Site Accessibility Evaluation

Fire Station 10

Accessibility Evaluation

SUBJECT: Fire Station 10 Self-Evaluation

Finding: 1

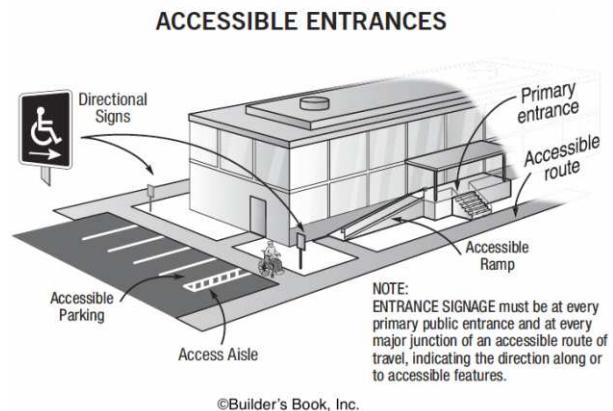
There is no accessible route of travel from the public way.

There is no accessible route from the public right of way.

Create an accessible route from the public right of way adjacent to driveway. This will need to be ramp this.

Finding: 2

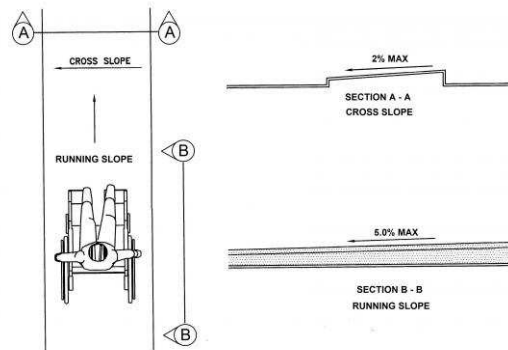
The accessible path of travel contains cross slopes greater than 2%.

The cross slope of the sidewalk within the driveway area is 4%.

Remove and replace the sidewalk area to achieve 2% maximum cross slope or as close to 2% as feasible.

Finding: 3

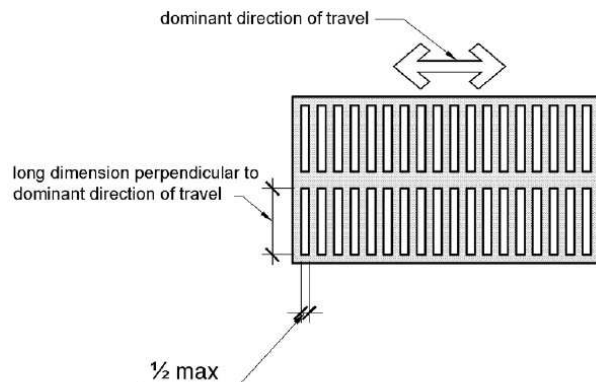
The fractures in the sidewalk impede access. One of the fractures is 1" deep by 4" wide by 6" long.

There is significant spalling and fracturing of the sidewalk.

Remove and replace concrete panels as needed to create an accessible path.

Finding: 4

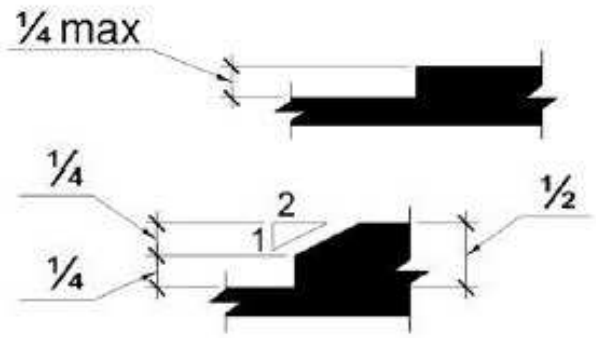
The walkway contains abrupt vertical edges and/or variations over a 1/4 inch.

The fracturing in the sidewalk has resulted in vertical displacement.

Remove and replace sidewalk panels as needed.

Finding: 5

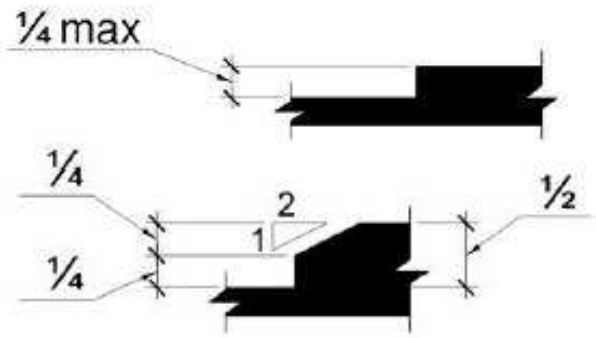
The walkway contains abrupt vertical edges and/or variations over a 1/4 inch. There is a chip in the sidewalk 1/2" deep by 2" wide by 14" long.

The spalling of the sidewalk has resulted in vertical displacement.

Cut and fill area.

Finding: 6

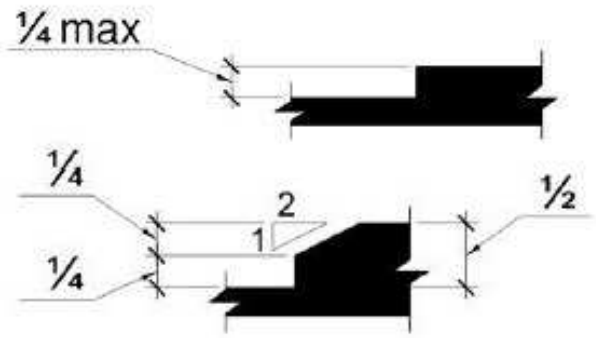
The walkway contains abrupt vertical edges and/or variations over a 1/4 inch.

There is significant fracturing in this section of sidewalk.

Remove and replace concrete panels as needed.

Finding: 7

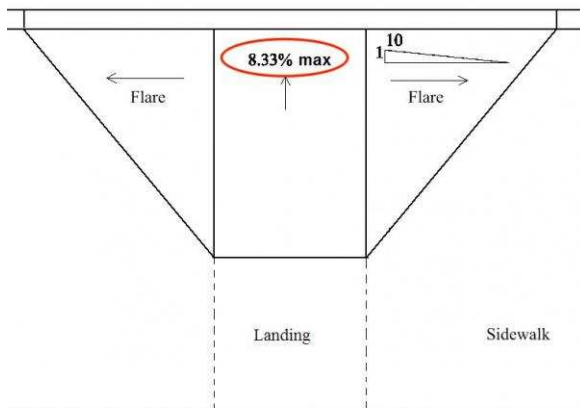
The Running Slope is up to 9%, vertical displacement exceeding 3/4", the landing has fracturing with a gap exceeding 1/2" and no detectable warnings. Also, side flare exceeds 10% in attached concrete.

This curb ramp has multiple issues.

Replace this ramp. The adjoining one is worse and needs replaced as well.

Finding: 8

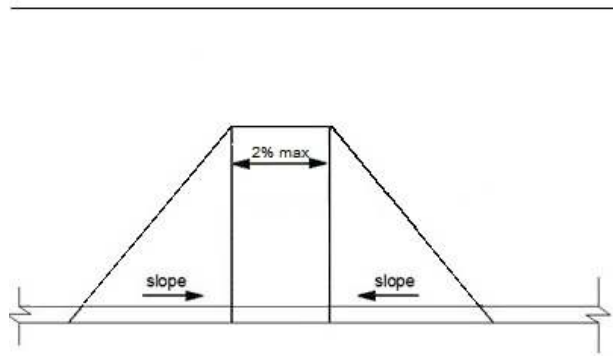
The cross slope of the curb ramp is 10% at the pavers at 7.5% at the above concrete ramp face.

The 9" across water main is sticking up across brick pavers 2' high.

The side flare in attached concrete is 17%

The ramp face has 1" vertical displacement from pavers to concrete.

The ramp has a landing with a 5% cross slope

This ramp has multiple problems, is failing fast and is a safety risk

Remove and replace the curb ramp crossing N Academy Blvd.

Finding: 9

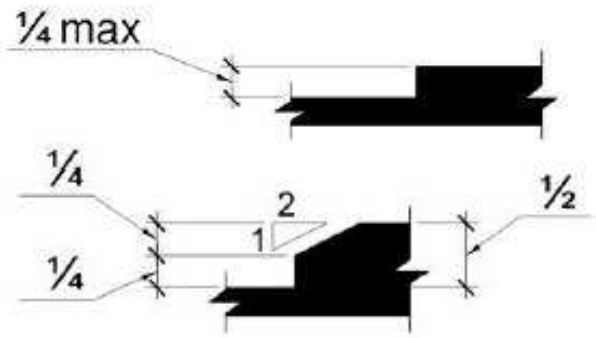
The walkway contains abrupt vertical edges and/or variations over a 1/4 inch.

There is a 1/2" vertical displacement at the landing at the entrance.

Grind to 1/2" or less bevel.

Finding: 10

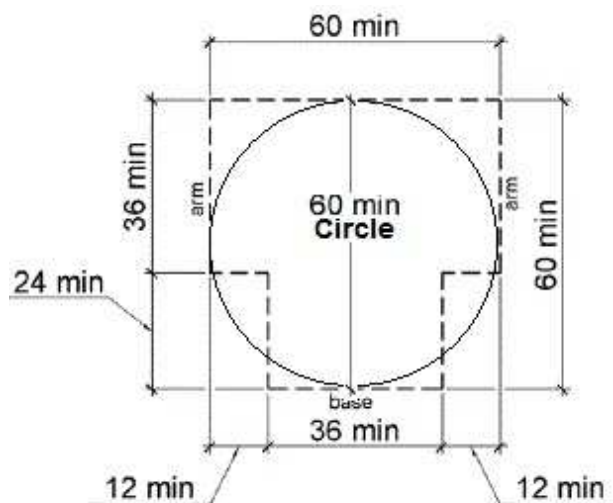
The T-shaped or circular turning space contains excessive slopes.

The landing at the entrance has 3.5% running slope.

Remove and replace the landing or create an accessible route elsewhere.

Finding: 11

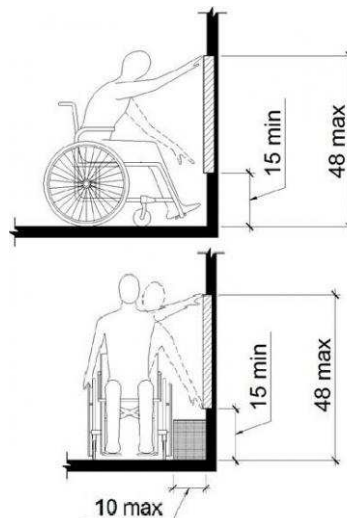
The door bell is positioned too high for either a side or front approach.

The door bell is mounted at 56".

Lower the door bell to 48" or less.

Finding: 12

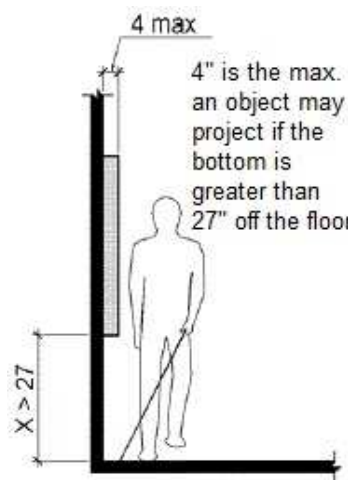
The mailbox and ash can project more than 4 inches into the circulation path.

The mailbox and ash can project into the path of travel.

Remove the ash can and relocate the mailbox so that not in the path of travel.

Finding: 13

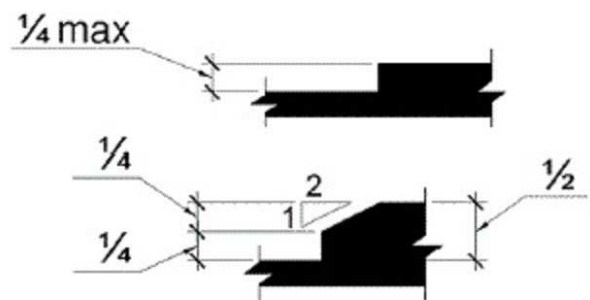
The threshold is greater than 1/2 inch high.

There is 3/4" threshold into the women's restroom.

Bevel the entrance into the restroom with a bridging plate.

Finding: 15

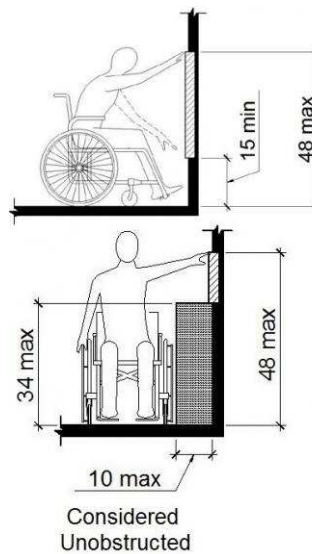
The coat hook is installed greater than 48 inches above the finished floor.

The coat hooks in the women's restroom are mounted at 66".

Lower the coat hook, or install another on at 48" maximum.
